## **CLSK SUBDIVISION**

APPLICATION NUMBER 3 DATE November 6, 2014

APPLICANT CLSK Subdivision

REQUEST Subdivision

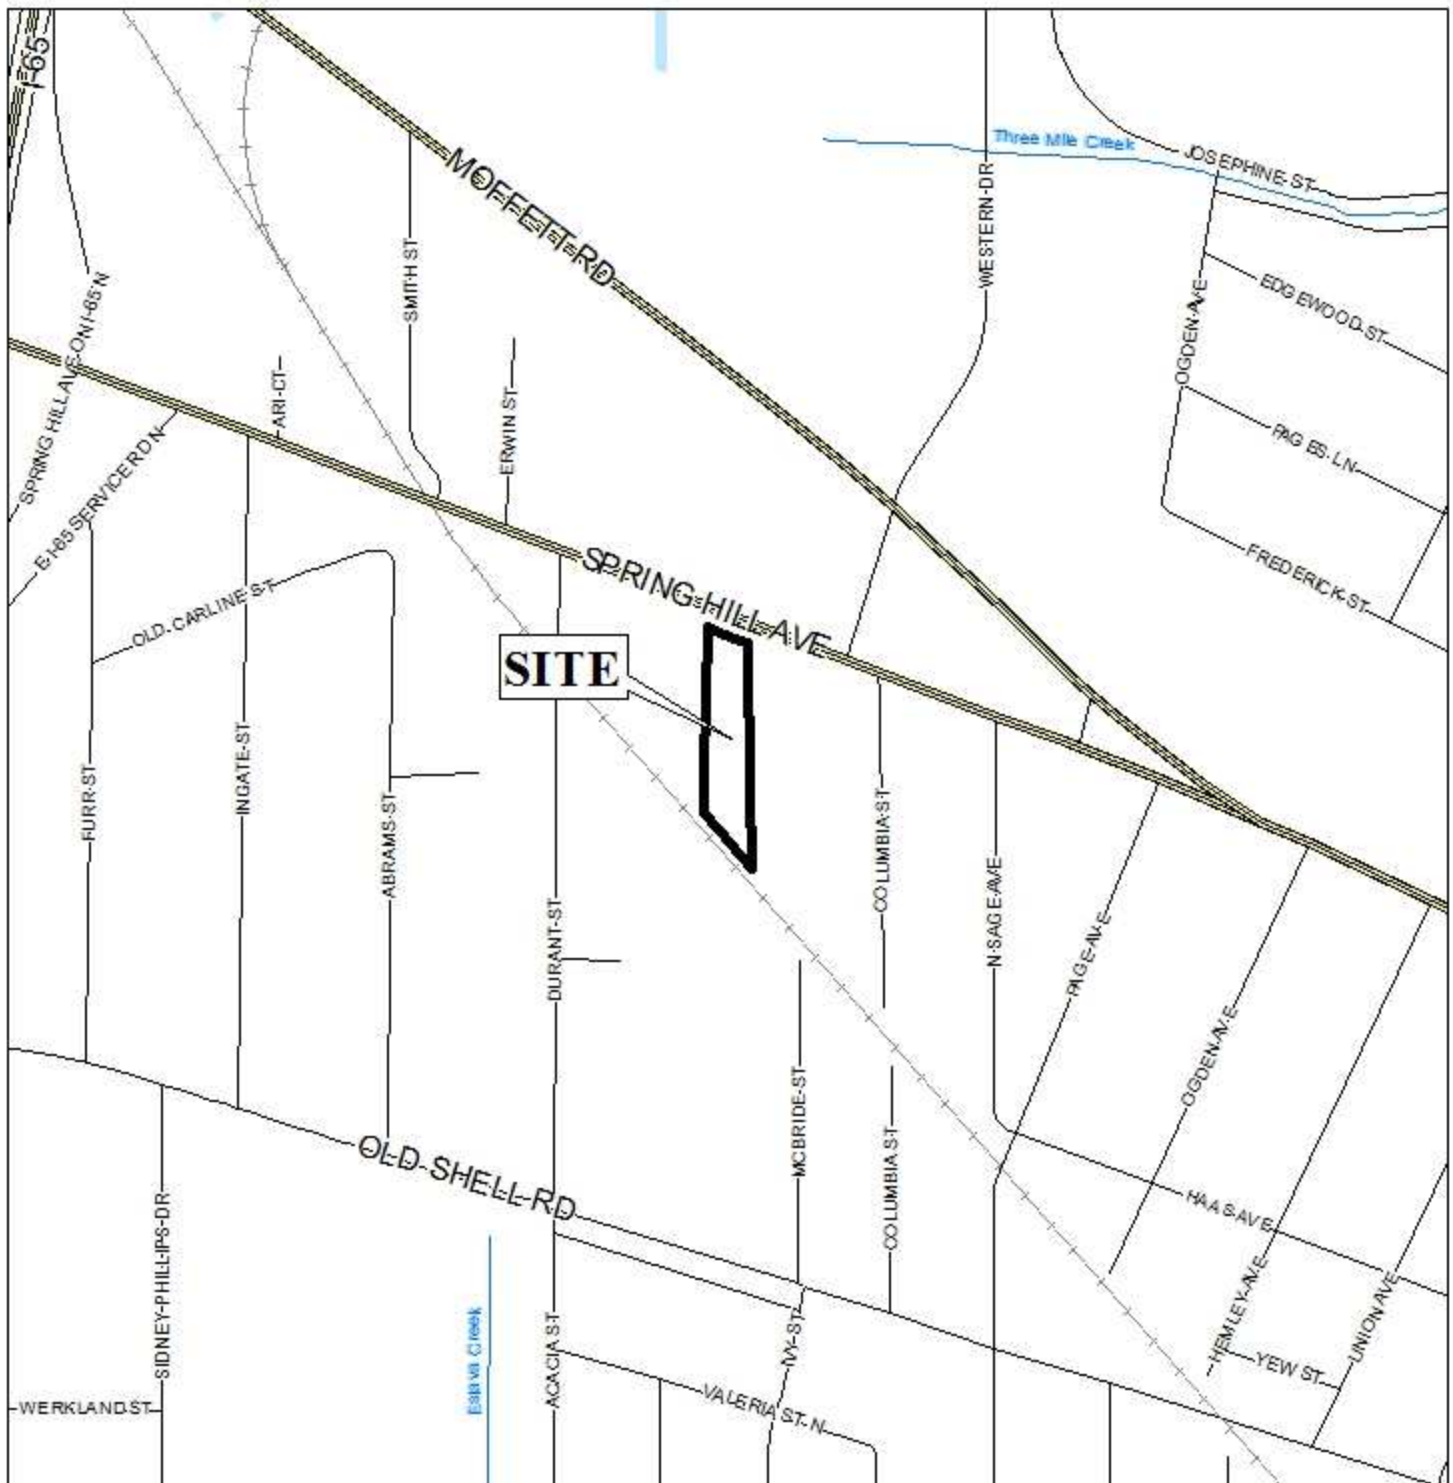
The proposed lot exceeds the minimum size requirements of Section V.D.2. of the Subdivision Regulations. However, it does not meet the 3.5 width to depth ratio, proposing instead a  $4.8 \pm$  width to depth ratio; thus, a waiver for Section V.D.3 of the Subdivision Regulations will be required. The plat currently depicts the lot size in acres but not in square feet. If approved, revisions should be made to depict the lot size in square feet and acres on the Final Plat, or a table should be furnished on the Final Plat providing the same information.

The 25-foot minimum building setback line, required in Section V.D.9. of the Subdivision Regulations, is not depicted or noted on the plat. If approved, revisions should be made on the Final Plat to illustrate the 25' minimum building setback line.

Due to the fact the site is adjacent to residential zoned property, located south, across the railroad tracks, a 6' high 10' wide vegetative buffer or a 6' wooden privacy fence will be required along the southern boundary of the site.

With a waiver of Section V.D.3. of the Subdivision Regulations, this application is recommended for Tentative Approval, subject to the following conditions:

- 1) illustration of the 25' minimum building setback line along Springhill Avenue on the Final Plat;
- 2) the labeling of the lot with the size in square feet and acres, or the furnishing of a table on the Final Plat providing the same information;

- 3) the placement of a note on the Final Plat stating that the site is limited to one two-way curb-cut, or 2 one-way curb-cuts onto Springhill Avenue with size, design, and location to be approved by Traffic Engineering and conform to AASHTO standards;

- 4) placement of a note on the Final Plat stating that a buffer in compliance with Section V.A.8. of the Subdivision Regulations will be required;
- 5) placement of a note on the Final Plat stating that approval of all applicable Federal, state and local agencies is required for endangered, threatened or otherwise protected species, if any, prior to the issuance of any permits or land disturbance activities;
